**SUBJECT:** Information Relevant To Item 9.3 – Project Scope – Rosebery Quietway

**Road Safety Audit – Rosebery Quietway**

### **Strategic Design Stage Road Safety Audit Report**

|     |  |              |                      | <i>For completion by Mott McDonald</i> |  |
|-----|--|--------------|----------------------|--|--|
|     |  <p>Spring St looking northbound to proposed Epsom Rd closure</p>  |              |                      |  |  |

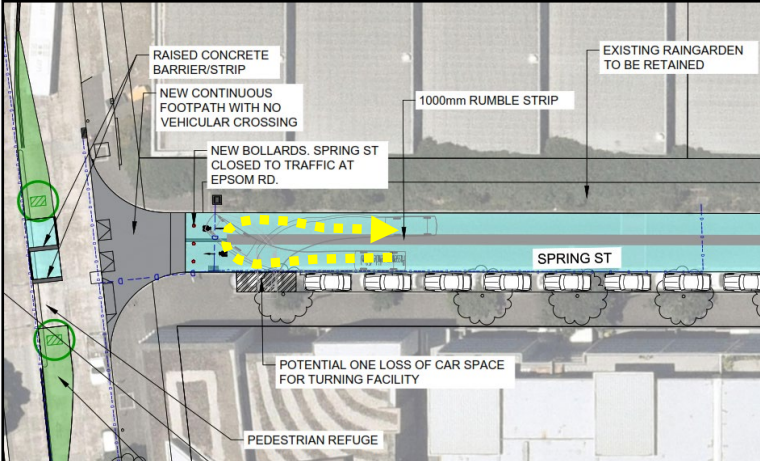
| No. | Description of Road Safety Issue   | Risk Rating | Road Safety Category | Action by | Response  |
|-----|--|-------------|----------------------|-----------|---|
| 2.  | <p>The swept path turning area (approximately 8.4 m carriageway width including the lost parallel car parking space) at the northern end of Spring Street (ie. at the Epsom Road closure) would require even smaller cars to perform 'multi-point' turn manoeuvres to U-turn, which is particularly undesirable amongst any passing bicycle movements – it is desirable that U-turn movements can be undertaken in a single, swept path rather than using a 'multi-point' turn movement.</p>  | Medium      | Road alignment       | CoS       | <p>Traffic is lightly to be very light since there are no destinations on Spring Str.<br/>           Addition could be a “No through road” sign at Rothschild/Steadman to reduce the risk still further.<br/>           This issue will be addressed in the detailed design</p> |
